Access Compliance Report

Public Rights-of-Way

Intersection ID: 50928	Main Street: GREAT_FUTURE_DR	Cross Street: MARVIN_RD	Location: SW
ADA ID: 12D4A5861E1F	Ramp Type: Perp	Initial Pass/Fail: Fail	Overall Compliance: No
			Severity Score: 12.5

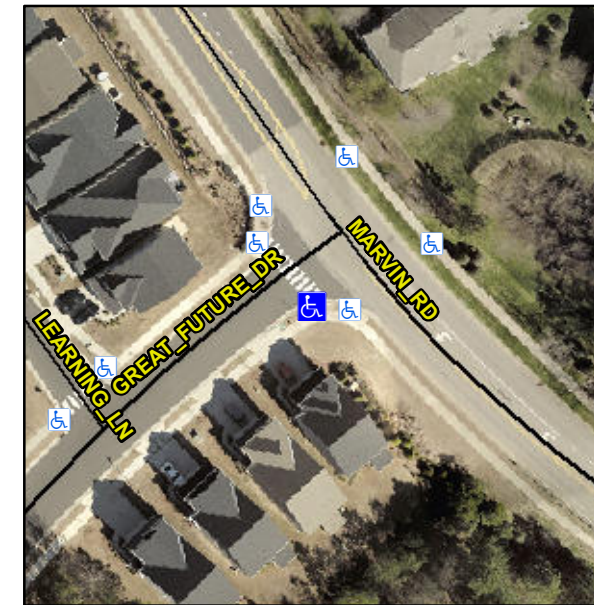
Not Found, R304.5.3

Compliance	Description	Data	Compliance	Description	Data
N/A	Ramp Length (in)	46.0	Yes	Ramp Slope (%)	5.5
Yes	Ramp Width (in)	50.0	No	Ramp XSlope (%)	5.2
N/A	Flare Type LT	N/A	N/A	Flare Type RT	N/A
N/A	Flare Slope LT (%)	N/A	N/A	Flare Slope RT (%)	N/A
N/A	Flare Traversable LT?	N/A	N/A	Flare Traversable RT?	N/A
N/A	Landing Length (in)	N/A	N/A	DWS Provided?	N/A
N/A	Landing Width (in)	N/A	N/A	DWS Contrast?	N/A
N/A	Landing Slope (%)	N/A	N/A	DWS Length (in)	N/A
N/A	Landing X Slope (%)	N/A	N/A	DWS Full Width?	N/A
N/A	Landing Curb? (Y/N)	N/A	N/A	DWS Offset (in)	N/A
N/A	Shared Landing?	N/A			
N/A	Gutter Ponding?	N/A	N/A	Gutter Slope (%)	N/A
N/A	Gutter Lip Ht (in)	N/A	N/A	Gutter X Slope (%)	N/A
N/A	Painted X Walk1?	Yes	N/A	Painted X Walk2?	N/A
	X Walk 1 Direction	To NW		X Walk 2 Direction	N/A
N/A	X Walk 1 Width (in)	120.0	N/A	X Walk 2 Width (in)	N/A
	X Walk 1 Slope (%)	5.8		X Walk 2 Slope (%)	N/A
	X Walk 1 X Slope (%)	3.5		X Walk 2 X Slope (%)	N/A

Remove & Replace Entire Ramp.
